# My unmatched forward region

# Using Guillaume's matched version

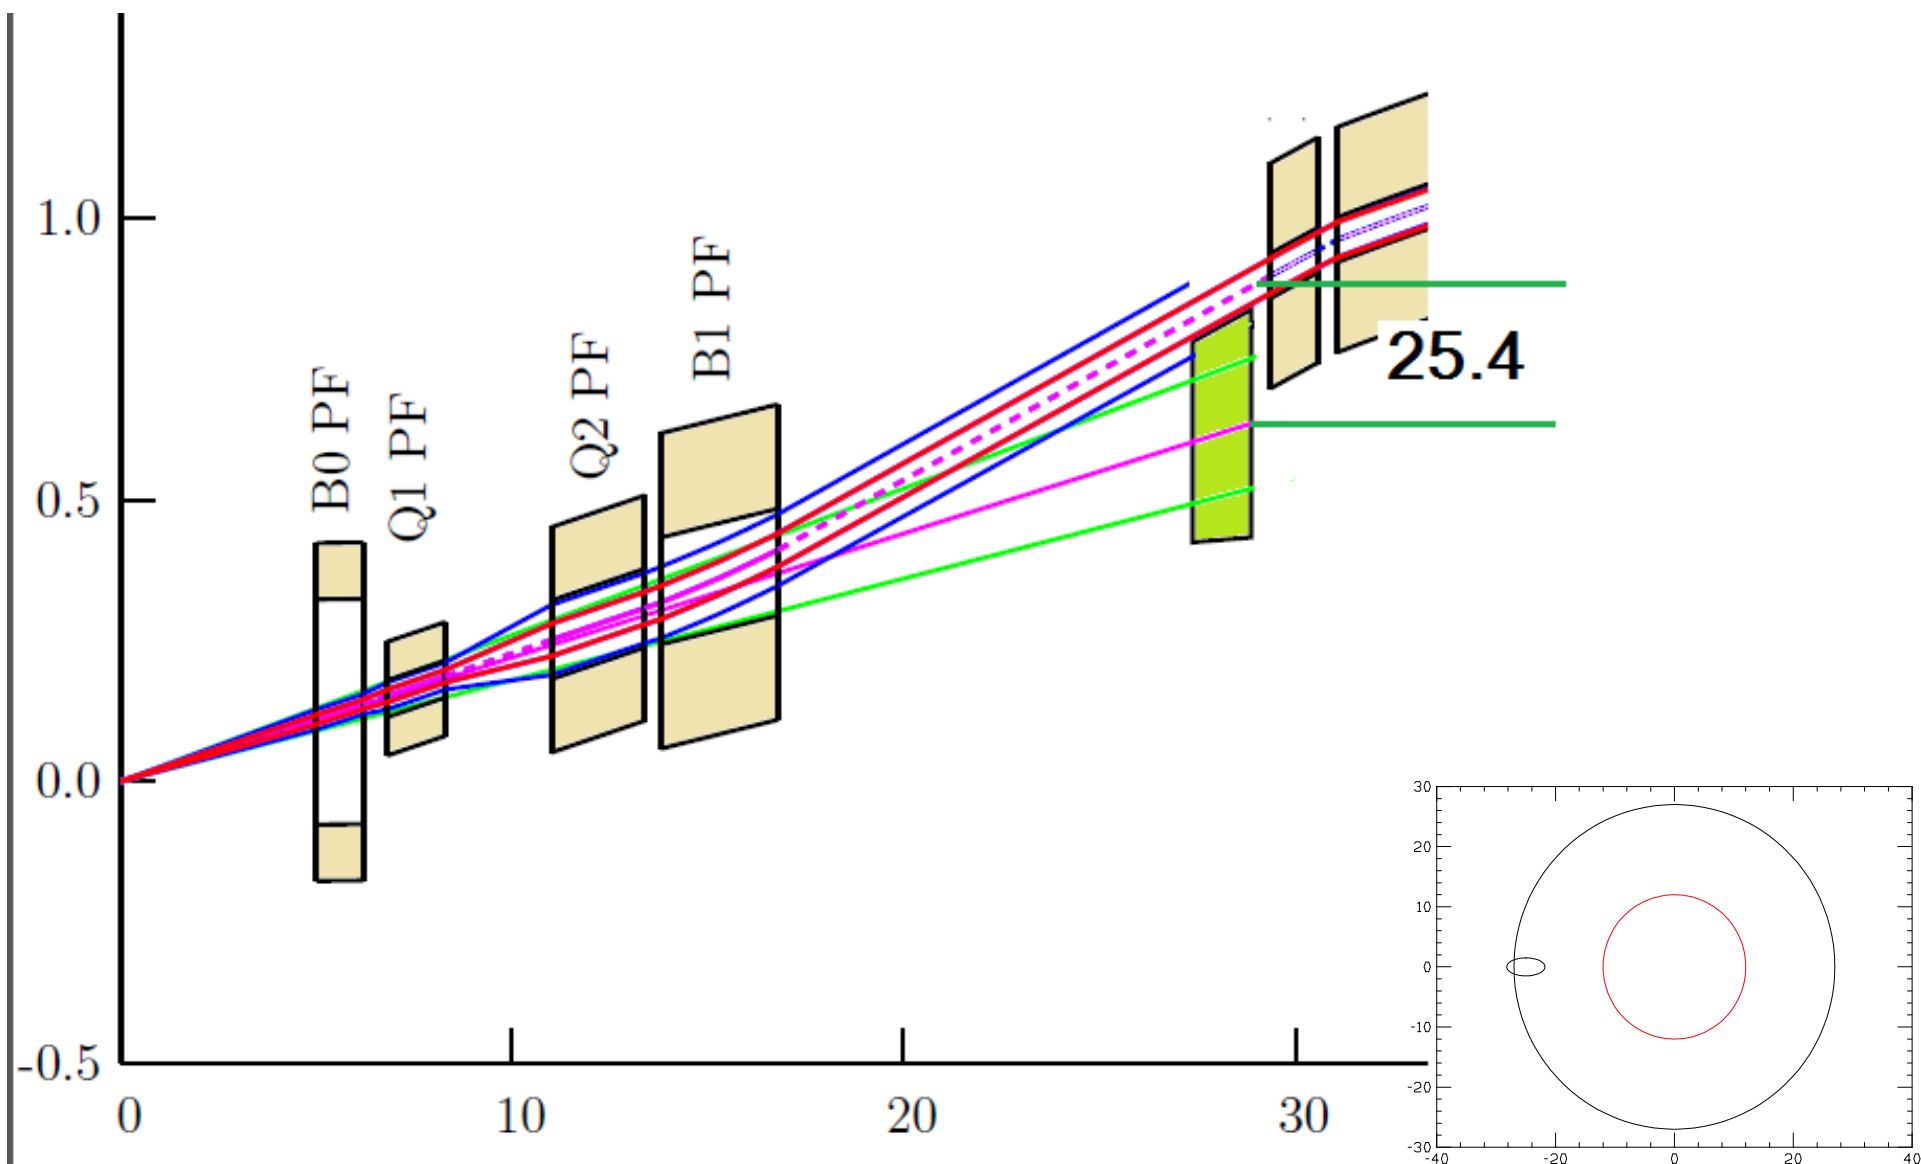
## Why?

- Distance to next magnet 30 instead of 40 m
- Magnet B1 moved 3 m down-stream

## Fixes:

- Move B1 back
- Place Detector after Roman pots (Alexander et al)  
ZDC can extend to beam its self

# Rear detail problem

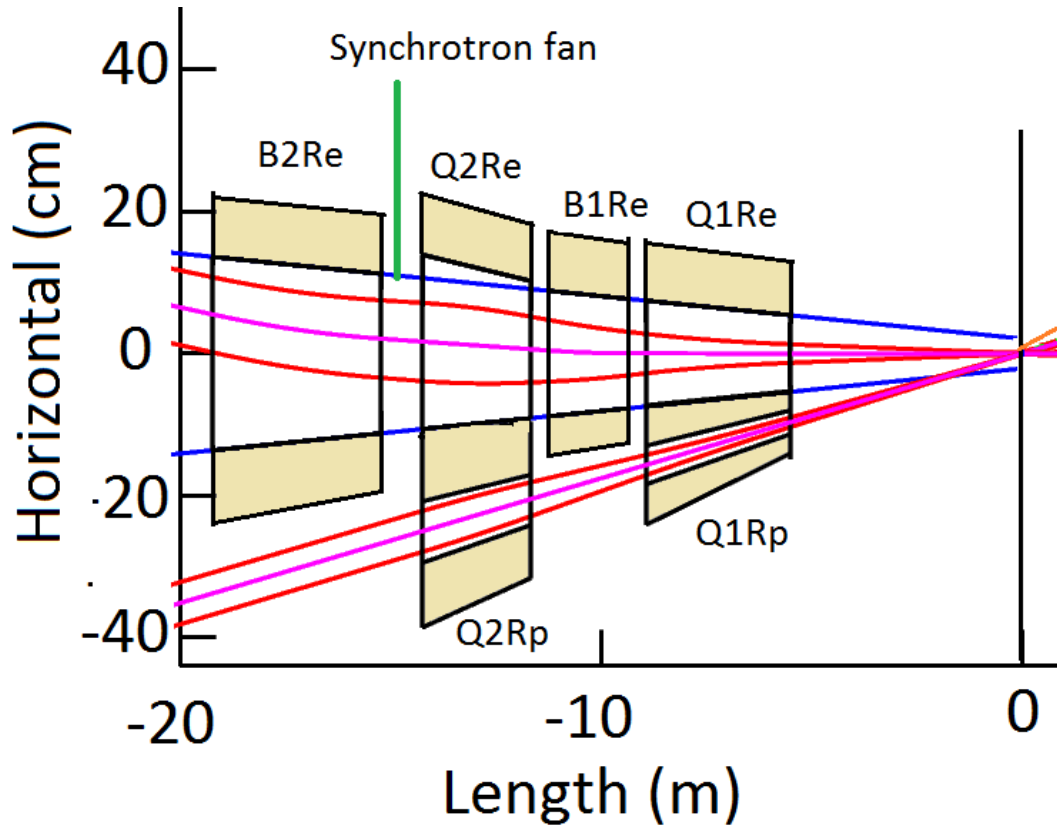
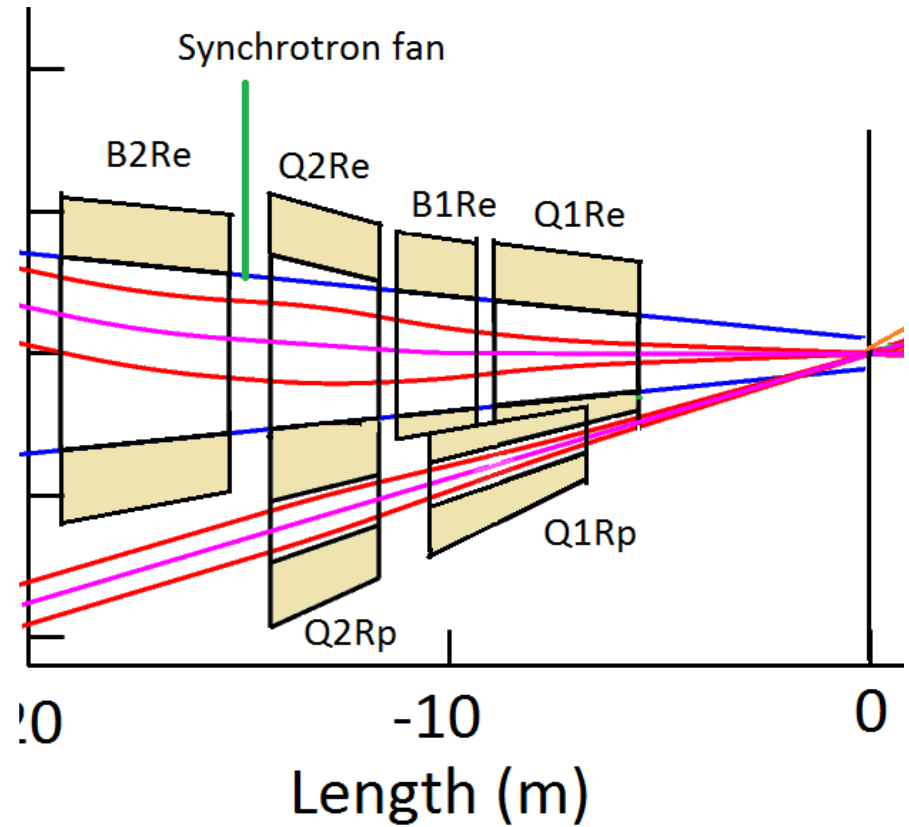
Holger did not like this

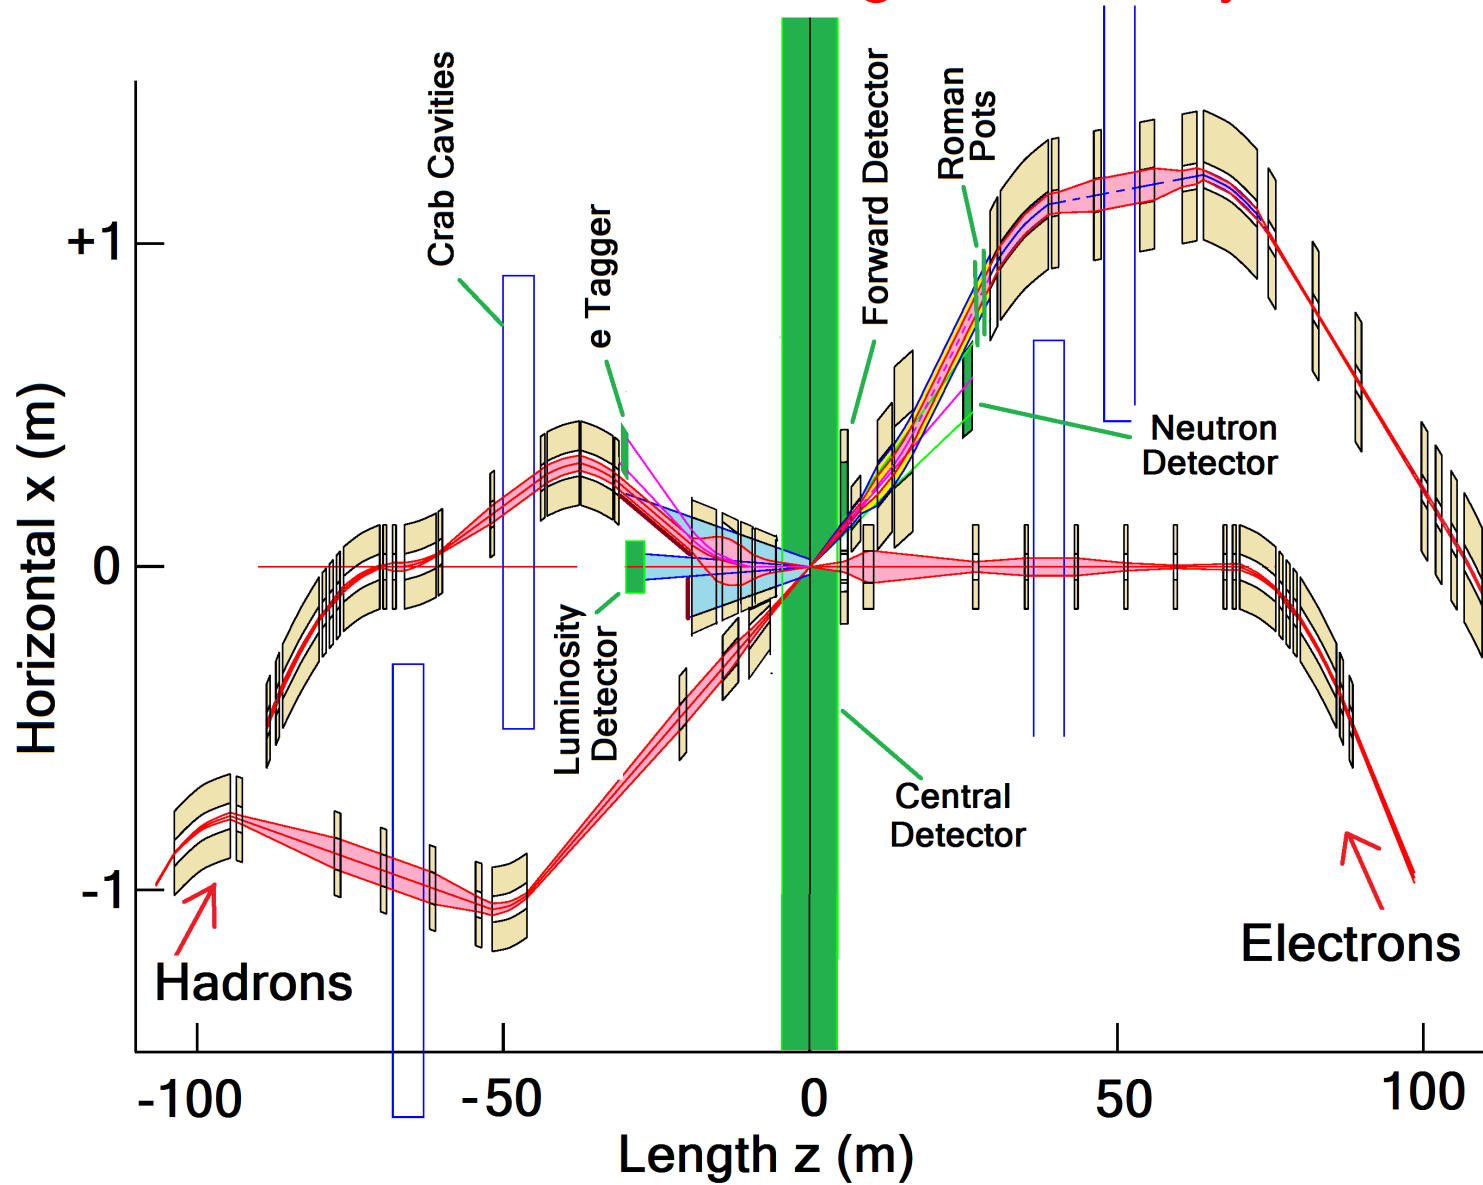
Apparent interference, but needs checking, could be my error

## Increased crossing angle and/or B1 field

- Increased crossing angle (e.g. 22→25 mrad) would greatly ease near in focus elements on both sides
- Increased B1 would recover beam to neutron cone space
